**DIRECT TESTIMONY  
OF  
GREG ROCKROHR**

**ENERGY ENGINEERING PROGRAM  
SAFETY AND RELIABILITY DIVISION  
ILLINOIS COMMERCE COMMISSION**

**Ameren Transmission Company of Illinois  
Docket No. 12-0598 (Rehearing)**

**November 13, 2013**

Page 11 from Staff's October 16, 2013, Exhibit A to Alternative Route filing, modified to show potential 345/138 kV substation site and AIC's existing 138 kV transmission lines.

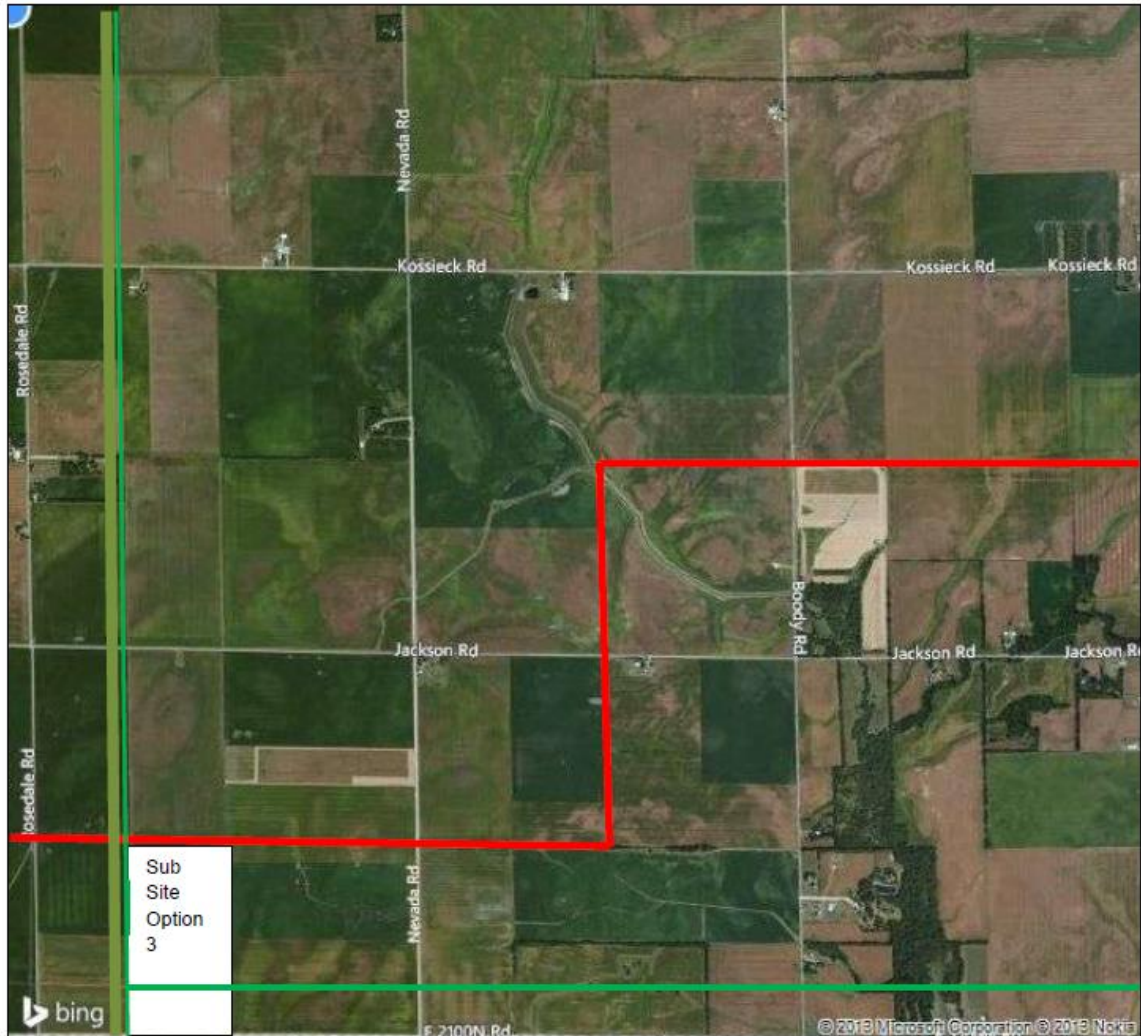
A. Yes. On October 25, 2013, I identified an additional location in Macon County, north of W. Hilvety Rd. (CR 2100N) and east of Rosedale Rd. that appears to be a very good choice for ATXI's 345/138 kV substation. This is because AIC already has an existing 138 kV line extending in three directions from this location: to the north to the Decatur area; to the south to AIC's existing Pana Substation; and to the east to an existing substation located just north of Moweaqua, along CR 3000N.<sup>8</sup> It appears to me that a 345/138 kV substation at this location could meet ATXI's, AIC's, and MISO's operational needs while minimizing impacts to landowners. Specifically, it appears to me that:

- 196           • AIC could use its existing 138 kV transmission facilities to supply the  
197           Decatur area from this new 345/138 kV substation, so that AIC would not  
198           need to, without delay, separately petition the Commission for a Certificate  
199           of Public Convenience and Necessity in order to construct 138 kV  
200           transmission lines and connections to supply the Decatur area, as I  
201           understand it would need to do if any of the other potential substation sites  
202           are used, including the site that ATXI proposes.

- 203           • Should AIC, ATXI, and/or MISO in the future determine that a second 138  
204           kV line to the Decatur area is necessary, AIC could extend the existing 138  
205           kV line that terminates at its existing substation north of Moweaqua, near  
206           Hwy 51.

- 207           • AIC's 138 kV transmission line that runs south from this location extends to  
208           AIC's existing substation at Pana, so that it appears that the same 345/138  
209           kV substation could reinforce AIC's 138 kV system in the Pana area.

- 210           • AIC's 138 kV transmission line that runs south from this location to Pana  
211           does not appear to connect to any other substation, and parallels a portion  
212           of ATXI's Primary Route previously submitted for the Pana to Mt. Zion  
213           segment. Therefore, if at some future date AIC, ATXI, and/or MISO  
214           demonstrate that, despite the existing 345 kV tie between Pawnee and  
215           Pana through Kincaid, an additional 345 kV tie to Pana is necessary, this  
216           existing 138 kV line route can be rebuilt/converted to a 345 kV line, thereby  
217           minimizing impacts to all property owners located along the route.

On page 11 of Exhibit A to Staff's Identification of an Alternative Route from Kincaid to Mt. Zion, filed on October 16, 2013, Staff indicates a route that crosses an existing 138 kV line just north of W. Hilvety Rd. (County Rd. 2100N) between Rosedale Rd. and Nevada Rd., in Macon County. Staff understands that Ameren Illinois Company ("AIC") owns and operates this 138 kV transmission line, and that from the location described above, this 138 kV line extends (1) south to Pana, (2) north to Decatur/Mt. Zion, and (3) east to an AIC-owned 138/34 kV substation located along County Rd. 3000N, west of Hwy 51, north of Moweaqua. Is Staff's understanding of the ownership and routing of this 138 kV line correct? If no, please identify the correct ownership and routing, if known.

If ATXI were to construct a 345 kV transmission line east from Kincaid along the route shown on page 11 of Exhibit A to Staff's Identification of an Alternative Route from Kincaid to Mt. Zion, would a connection between AIC's 138 kV lines that exist north of Hilvety Rd. and east of Rosedale Rd. to a new ATXI 345/138 kV substation constructed north of Hilvety Rd. and east of Rosedale Rd. provide an adequate additional 345 kV source for both the Decatur and Pana areas, so that additional 345/138 kV substations near Pana and Mt. Zion could be eliminated or deferred? If it would not, please state in detail why this is the case, and provide and explain specific study scenarios wherein unacceptable voltage and/or loading would exist with ATXI's 345/138 kV substation connected as described in this data request.

If ATXI were to construct a new 345/138 kV substation north of Hilvety Rd. and east of Rosedale Rd., and AIC were to connect its existing 138 kV transmission line that runs between Pana and Decatur to that new 345/138 kV substation, as described in Staff data request ENG 11.02, could AIC and/or ATXI provide an additional 138 kV source to the Decatur area by extending its 138 kV line from AIC's existing substation, located on County Rd. 3000N west of Hwy 51? If not, please explain why not.

Staff's understanding of the ownership and routing of the above described 138 kV line is correct. However the AIC-owned substation (which is named Moweaqua North) located along County Rd. 3000N, west of Hwy 51, north of Moweaqua is a 138/69 kV substation and not 138/34 kV.

ATXI objects to this request as outside the scope of rehearing. The request proposes the construction of a new substation west of Moweaqua and so a system configuration that is not mentioned or described in Staff's proposed Kincaid-Mt. Zion route submittal. The Commission's Final Order declined to grant a Certificate for the Pawnee – Pana and Pana – Mt. Zion segments of the Illinois Rivers project because it found persuasive Staff's argument that ATXI and MISO failed to consider whether it would be preferable to have a line from Kincaid to Mt. Zion. (Order, p. 83-84.) However, the Commission found a substation in Mt. Zion necessary. (Order, p. 86.) ATXI sought rehearing to provide an opportunity for the Commission to consider additional evidence substantiating the operational and reliability benefits associated with a Pawnee-Pana-Mt. Zion route as compared to a Kincaid option. No party, however, sought rehearing on the conclusion that the Mt. Zion substation is necessary. The Commission granted ATXI's application for rehearing, and the ALJs directed that "consistent with the Commission's direction from the Bench on October 2, 2013, that Commission Staff shall identify a transmission line route between Pawnee and Mt. Zion (via Kincaid) as soon as possible. Staff filed a transmission line route between Pawnee and Mt. Zion (via Kincaid) and proposed Mt. Zion substation locations on October 7,

1. The proposed substation would provide only a single 138 kV connection from the new substation to the Decatur area, while ATXI’s proposed Mt. Zion substation location provides two shorter length 138 kV connections to the Decatur area. Therefore the Illinois River Project provides a stronger and more reliable supply to the Decatur area.

2. For certain potential outages of the Oreana substation 345/138 kV transformers, ATXI expects the post contingency voltages in the Decatur area would only be approximately 91-92% of nominal. This is below the acceptable voltage level of 95% as stated in my previous testimony and approaching the level that carries significant risk for voltage collapse. As I explained in my direct testimony, “The voltage criteria used by Ameren Services for system planning has been developed to provide voltages to the customer consistent with the Standards of Service for Electric Utilities contained in 86 Ill. Adm. Code Part 410. Transmission system voltage below 95% of nominal has been established as an indication of a possible deficiency. Conditions which result in 86% - 89% voltages in the steady-state analysis carry significant risk for voltage collapse.”

3. Ameren Services expects that equipment overloads on the Ameren transmission system, especially the 138 kV system, would occur if certain NERC Category C events occurred at the Kincaid substation which resulted in splitting the ring bus configuration. These overloads would need to be addressed with additional system reinforcements.

4. The hypothetical substation would not provide an additional 345 kV supply to the Pana substation and is therefore not adequate to address the need for an additional 345 kV supply and associated substation near Pana.

5. Ameren Services expects that additional future system development will probably continue in the Decatur area. Although not expected in the short term, a possible result would be the creation of a 345 kV circular electrical path around the Decatur and Mt. Zion area. Locating the new 345/138 kV substation as described in this DR would result in longer 345 kV lines to connect it to the circular electrical path. This will result in greater expense to develop the circular path. The development of the circular electrical path would probably be driven by the need to address system reliability issues, therefore the Ameren Illinois customers would be required to pay 100% of the cost of the longer 345 kV lines to connect to the new substation. One of the reasons why the Illinois Rivers Project located the new Mt. Zion substation farther northward than proposed by this DR is to reduce the length of these potential future 345 kV lines associated with a circular electrical path around the Decatur and Mt. Zion area.

Therefore ATXI does not believe the hypothetical substation location and system configuration would be an adequate substitute such that additional 345/138 kV substations near Pana and Mt. Zion could be eliminated or deferred.
